Addendum #2

Project Name: Nebraska History Museum Renovation
131 Centennial Mall N.
Lincoln, NE 68508

Project No.: 13059-05

DRAWING TITLE
Nebraska History Museum
Ground Level
15th and P Street
Lincoln, NE 68508

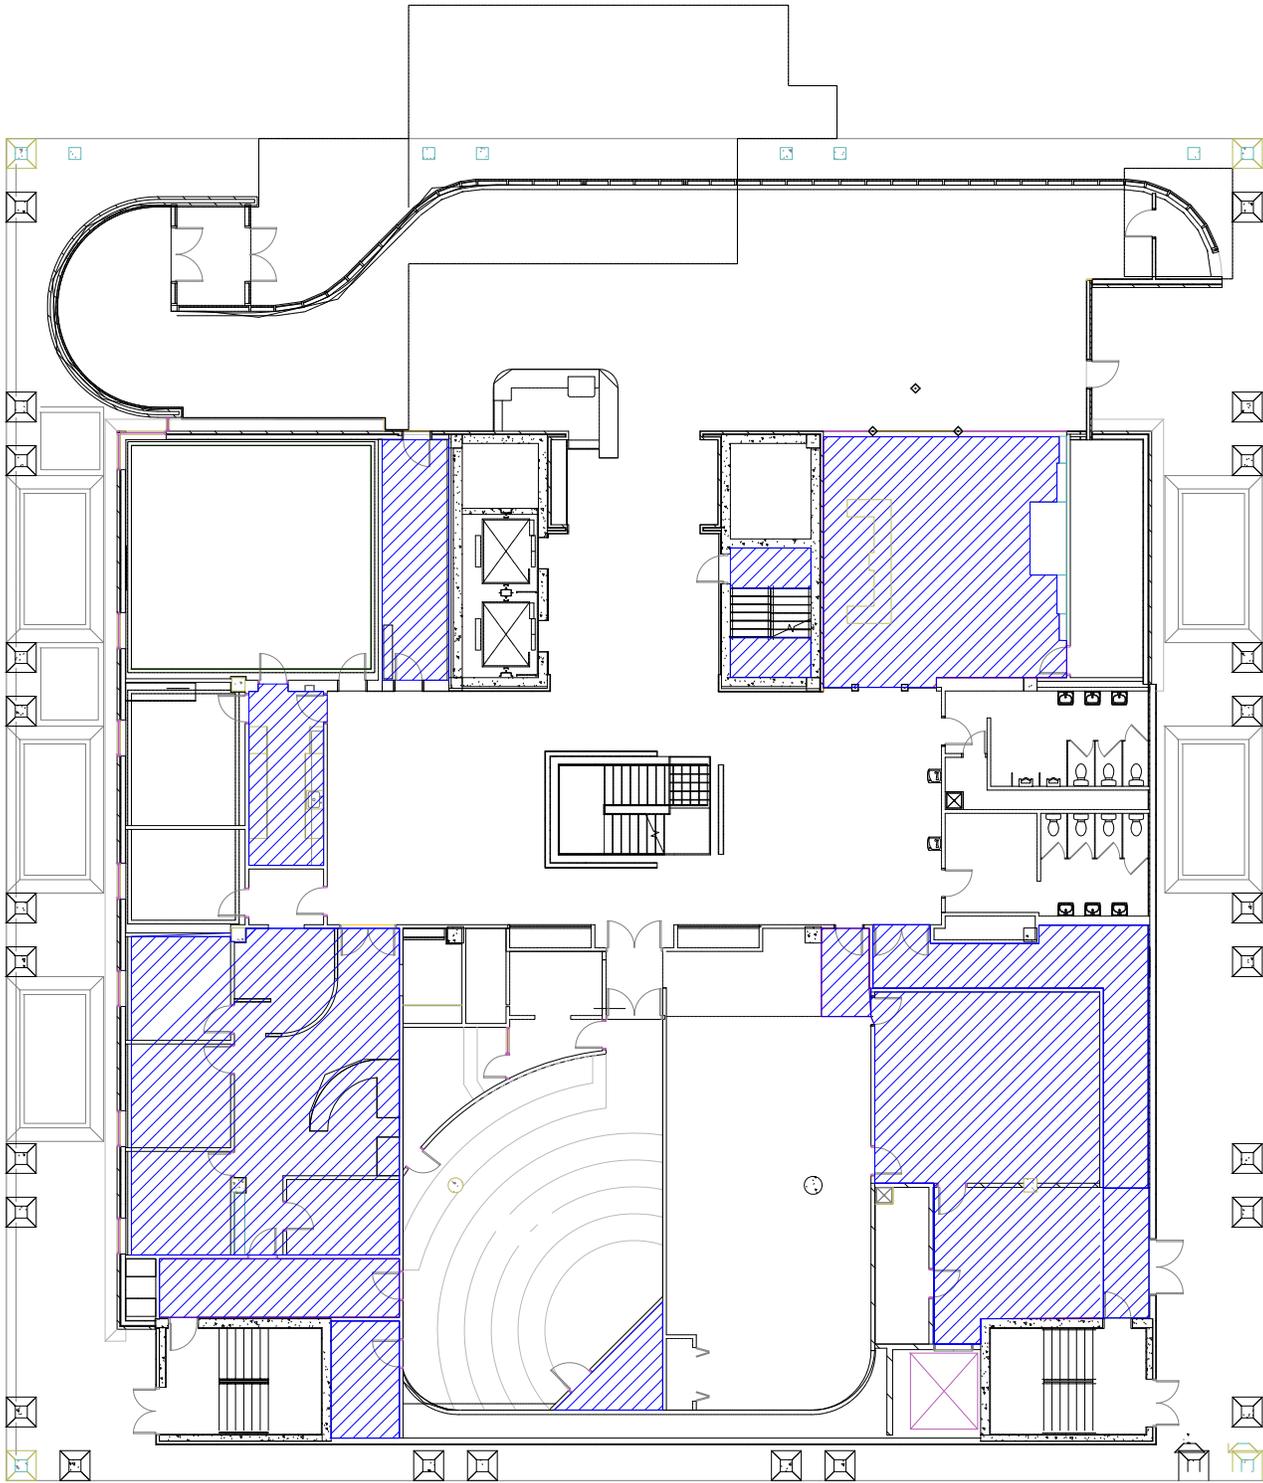
1. The Owner has identified the scope of work associated with floor abatement and has released those documents out for bid. Attached is a copy of the abatement plans (being bid under separate contract) for use in clarifying the areas where coordination between the contracts will be required. Refer to **Attachments 1 of 6, 3 of 6 & 5 of 6**.

3. The majority of abatement work is indicated on Third Level. It would be preferable to allow the abatement work to begin on Third and move down from there. General Contractor to coordinate accordingly.

DRAWING TITLE
 Nebraska History Museum
 Second Level
 15th and P Street
 Lincoln, NE 68508

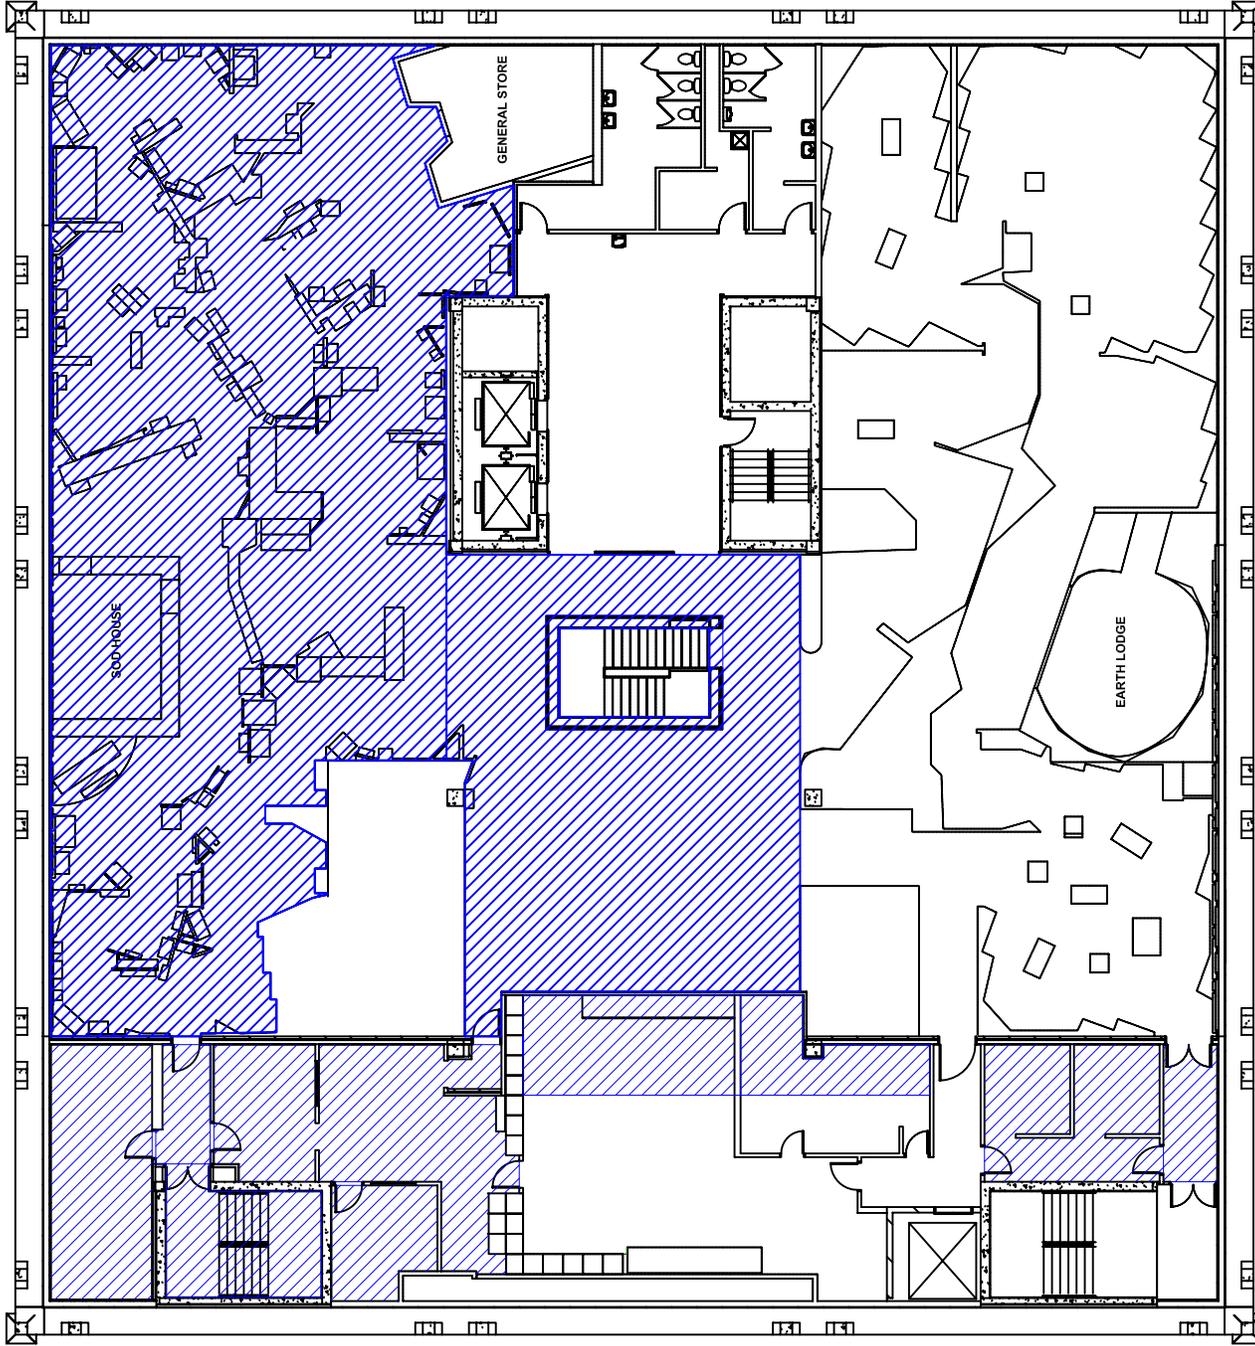
4. Stair railings should NOT be removed until the abatement contractor has completed their scope of work.
5. The abatement contractor will require openings in the exterior walls on Second and Third Levels for access to fresh air. General Contractor to provide required openings. Openings should be located where scheduled openings 201C and 301C are shown. Contractor's option to cut smaller required opening as needed for abatement or to cut entire opening as required for final door installation.
